PRODUCT CHANGE | MEDIUM HD BRACKET ADAPTOR

| | PRODUCT DETAILS | NO CHANGES MADE |
|--------------|---|--|
| DESCRIPTION. | AUTOMATE E6 [35mm/6.0Nm/33r] ARC-MTR240V | <input checked="" type="checkbox"/> |

| | PRODUCT DETAILS | NO CHANGES MADE |
|--------------|---|--|
| IMAGE. | PREVIOUS VERSION | NEW VERSION |

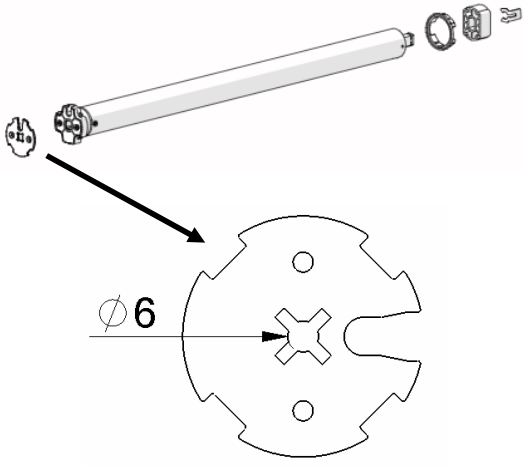
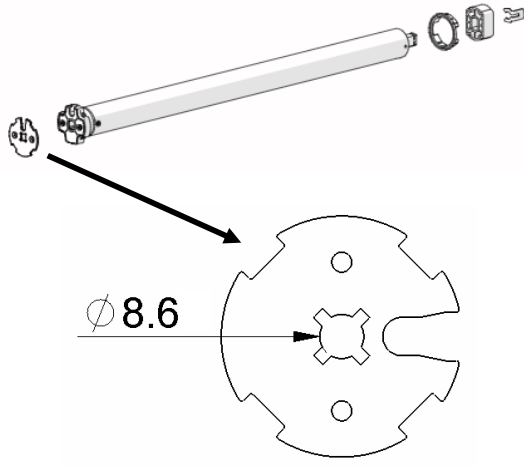
- New disc adaptor is compatible with the HD Bracket Adaptor (RB09-0701-xxx012)
- Disc adaptor internal diameter increased to 8.6mm
- The use of the HD Bracket Adaptor will allow E6 & M6 motors to be installed on our range of single and double brackets.
